# UNITED STATES PATENT AND TRADEMARK OFFICE

APPLICATION NO.	FILING DATE	FIRST NAMED INVENTOR	ATTORNEY DOCKET NO.	CONFIRMATION NO.
09/801,409	03/08/2001	Gajender Rohilla	CD 00-214	2883
20575	7590	10/20/2004	EXAMINER	
MARGER JOHNSON & MCCOLLOM PC 1030 SW MORRISON STREET PORTLAND, OR 97205			RODRIGUEZ, ARMANDO	
			ART UNIT	PAPER NUMBER
			2828

<b>Office Action Summary</b>	<b>Application No.</b> 09/801,409	<b>Applicant(s)</b> ROHILLA, GAJENDER	
	<b>Examiner</b> ARMANDO RODRIGUEZ	<b>Art Unit</b> 2828

## **DETAILED ACTION**

U.S. Patent No. 24, 1987 Sheet 2 of 2 4,709,370

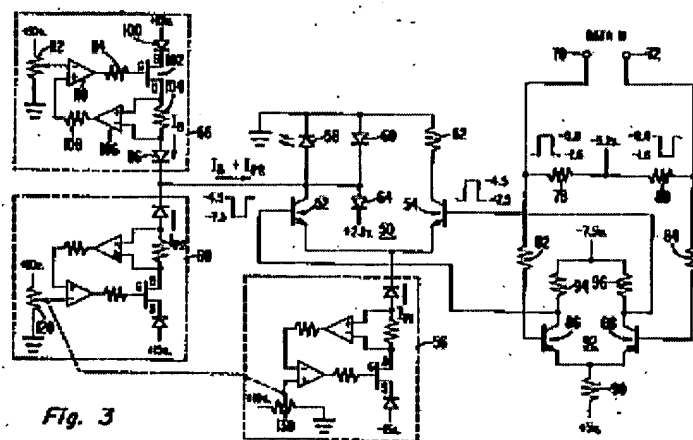
Figure 3 illustrates a circuit having two transistors (52) [applicant's first transistor] and (54) [applicant's second transistor], where the transistors each receive an input signal [applicant's two inputs], a constant current source (56) [applicant's first current source], which is connected to both transistors (52) and (54), a constant current source (68) [applicant's second current source], which is connected to transistor (52), as described in column 3 line 53 to column 4 line 3. Column 3 line 67 to column 4 line 1 and column 5 lines 42-43, describes the constant current sources (56) and (68) as substantially equal. As illustrated in figure 3 and described in column 3 line 53 to column 4 line 3, current source (56) provides a first current, current source (68) provides a second current and current source (66) provides a third current, where the second current and the third current which is substantially equal to the second current minus the first current will be delivered to the laser diode (58).

Column 5 lines 23-34 describes the switching scheme of the transistors (52) and (54), where the second amount of current is delivered to the laser diode when the transistor (54) has a high logic state.

Column 5 lines 23-34 describes the switching scheme of the transistors (52) and (54), where the third amount of current ( $I_B$ ) is delivered to the laser diode when the transistor (52) has a high logic state.

Figure 3 illustrates the use of Bipolar transistors, as described in column 3 lines 53-57 as NPN transistors.

Figure 3 illustrates the inputs connected to the base of the transistors (52) and (54), as described in column 4 lines 40-42.

Figure 3 illustrates current source (56) connected to the common emitters of the transistors (52) and (54), as described in column 4 lines 1-3.

Figure 3 illustrates current source (68) connected to the collector of transistor (52).

Figure 3 illustrates a semiconductor laser diode (58), as described column 3 line 61.

Figure 3 illustrates the laser diode connected to the collector of transistor (52).
